**TOWN OF DAVIDSON
DESIGN REVIEW BOARD
7:00PM Board Room in Town Hall a 216 S Main St, Davidson, NC**

Town of Davidson, NC
Design Review Board: Staff Analysis
July 17, 2019

Project: Wells Fargo ATM (Exxon Station Site)
Location: 601 Griffith Street (Parcel ID 00321403)
Applicant: Matthew Kiger, SVW Inc.
Designer: James M. Hammill, Prizm Architects
Planning Area: Special Use

Revised Wells Fargo ATM Renderings for Design Review Board (7/17/19)

GENERAL NOTES:
1. ALL WORK IS TO BE COORDINATED WITH THE BRANCH REPRESENTATIVE.
2. FOR STRUCTURAL AND ELECTRICAL DETAILS REFER TO MANUFACTURER DRAWINGS AND SPECIFICATIONS.

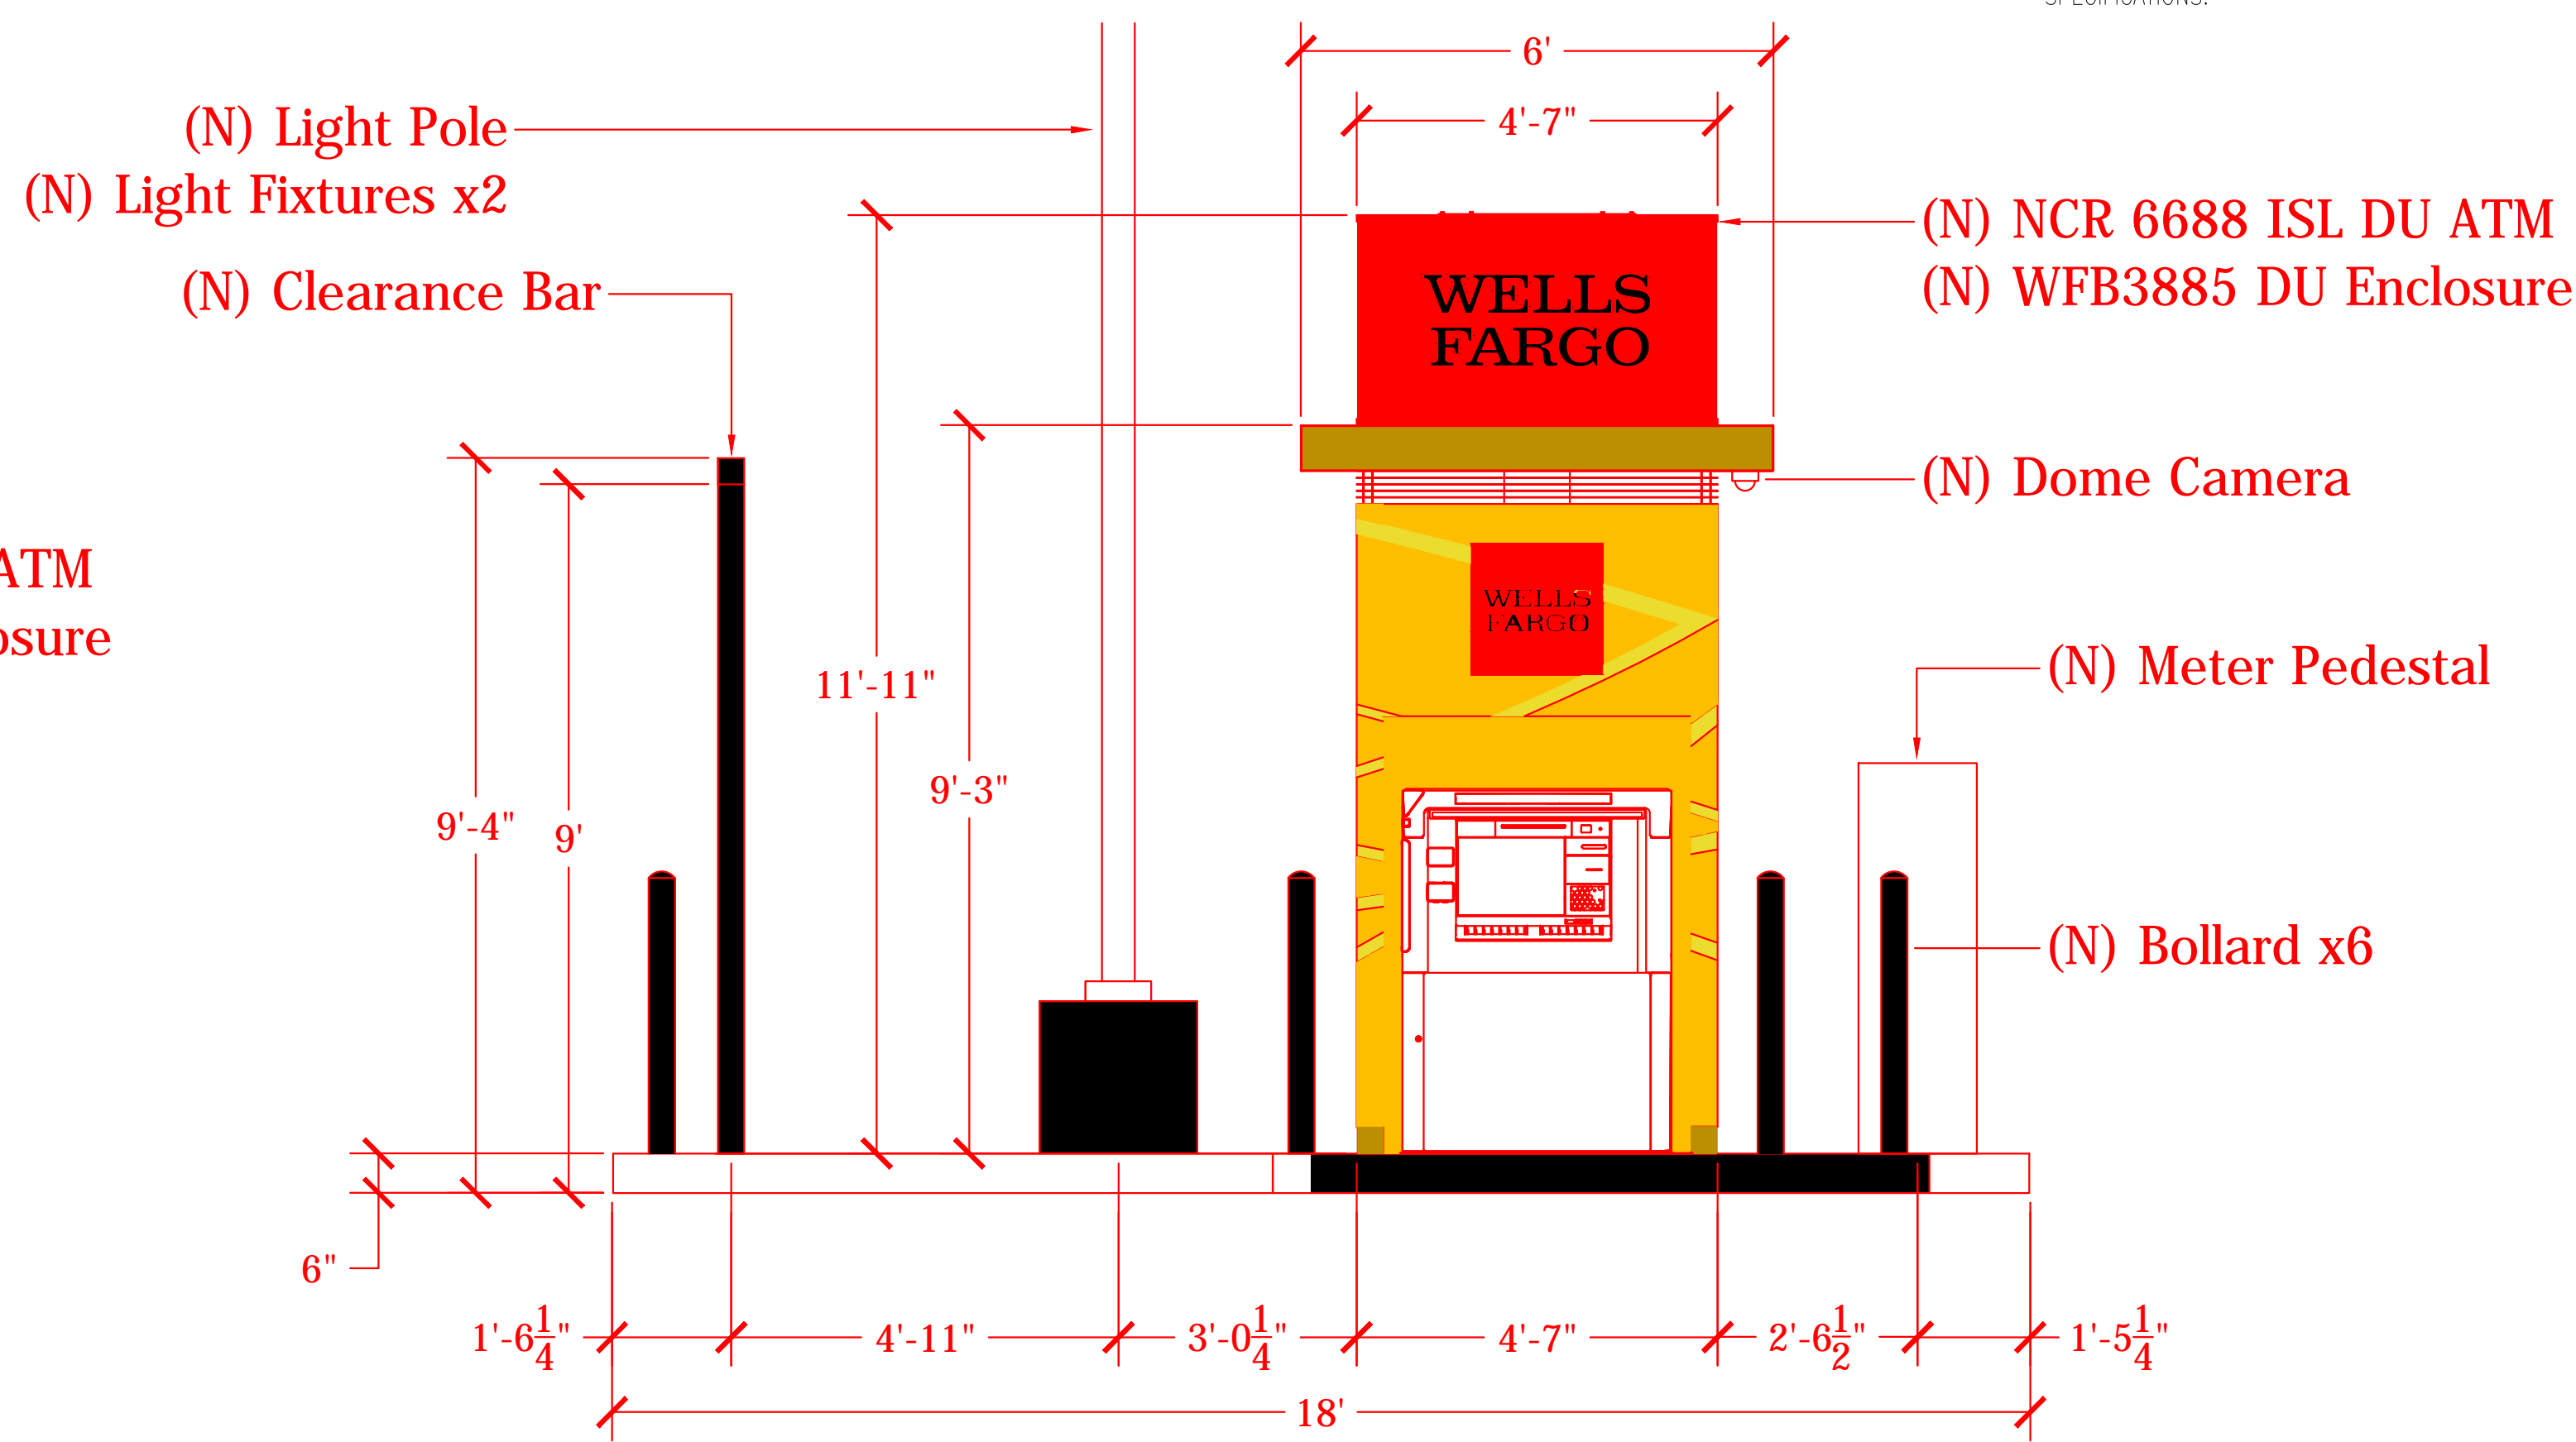
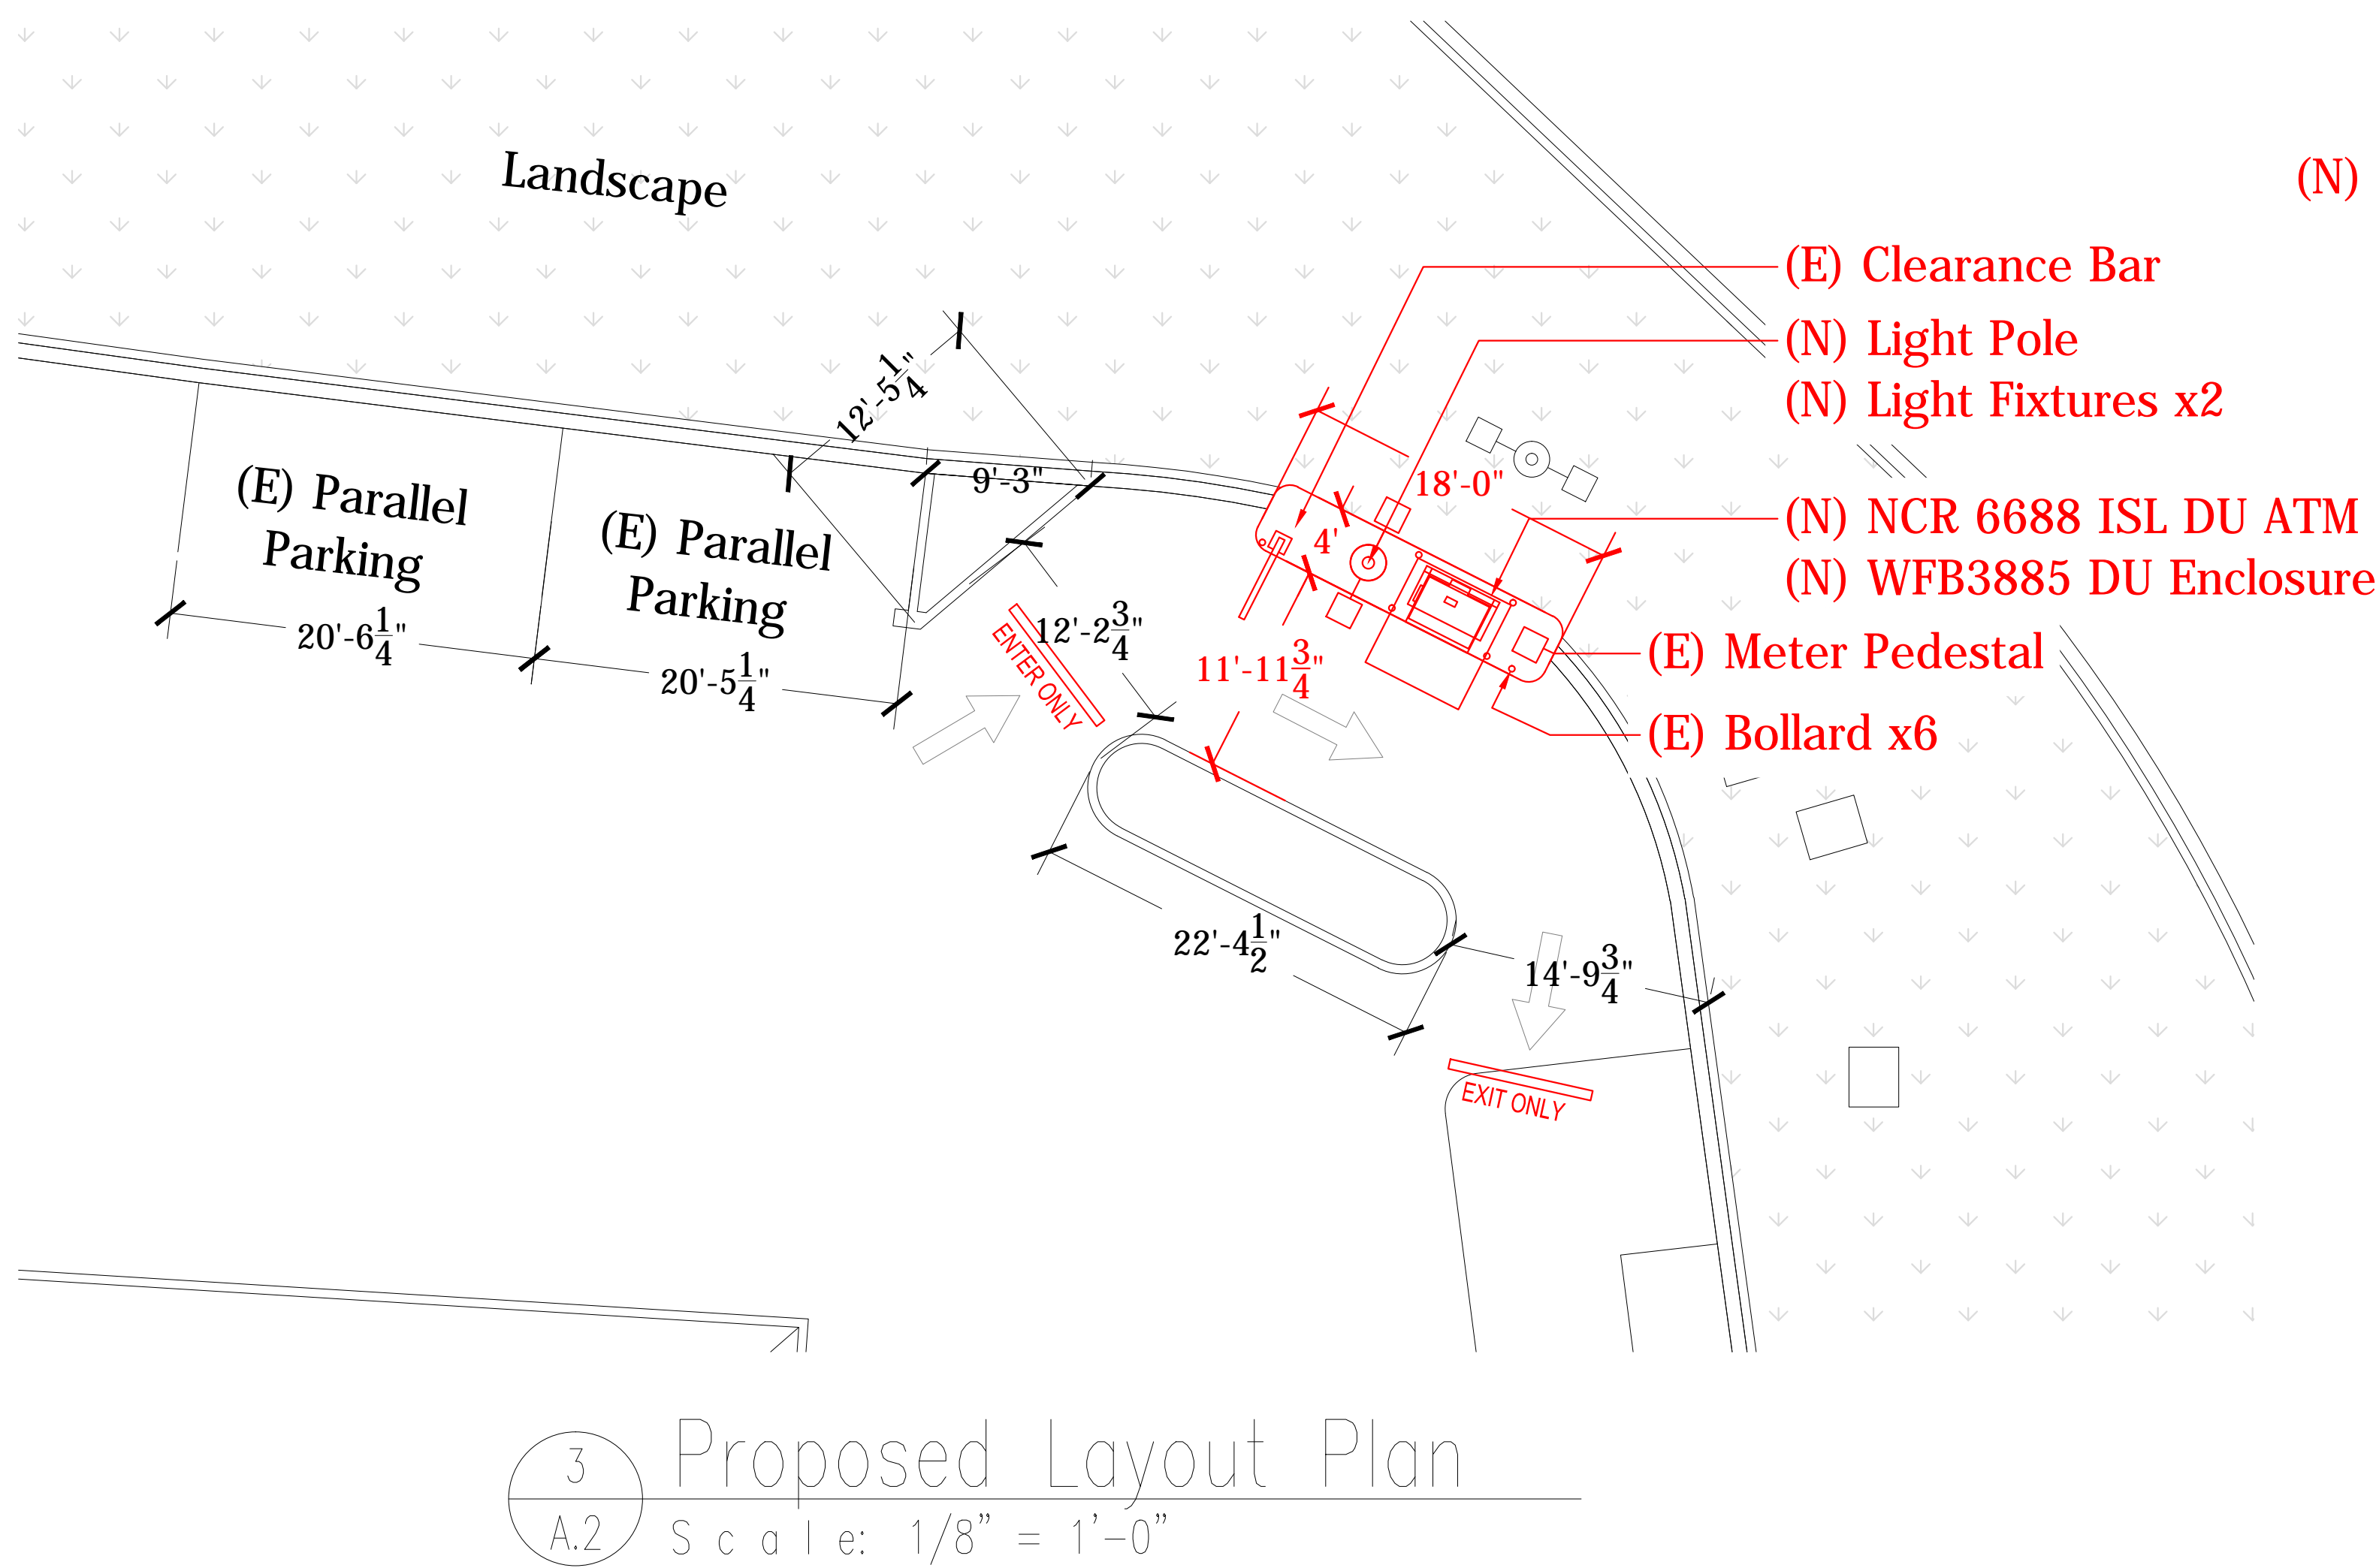
TG noted that materials must be complementary to the materials already being used in the neighborhood. The existing buildings adjacent to this site are primarily brick. Additionally, an electrical meter is shown on a pedestal facing the street in the plans submitted.

After further discussion, a motion (BS) was made to continue the project with the following requested changes: 1) the ATM enclosure shall be clad in brick to match adjacent buildings, 2) the electrical meter shall be reoriented so that it faces away from the side of the ATM structure and does not face the parking lot or the street, 3) the color of the light pole base and clearance bar shall be painted to match the meter pedestal (bronze), and 4) the signage on top of the ATM canopy shall not be internally illuminated. The motion was seconded (TG) and approved unanimously.

This case was continued at the June 19 DRB meeting with the following requested changes: 1) the ATM enclosure shall be clad in brick to match adjacent buildings, 2) the electrical meter shall be reoriented so that it faces away from the side of the ATM structure and does not face the parking lot or the street, 3) the color of the light pole base and clearance bar shall be painted to match the meter pedestal (bronze), and 4) the signage on top of the ATM canopy shall not be internally illuminated.

The location of the proposed ATM has not changed and will be located at the corner of the parking lot near the Griffith/Jetton St roundabout. The updated renderings of the proposed ATM show a change in exterior materials from metal/plexiglass to brick. The updated renderings also indicate that the electrical meter will no longer face the Griffith Street/Jetton Street roundabout. The applicant also indicated that the Wells Fargo signage on top of the ATM canopy can be installed without internal illumination.
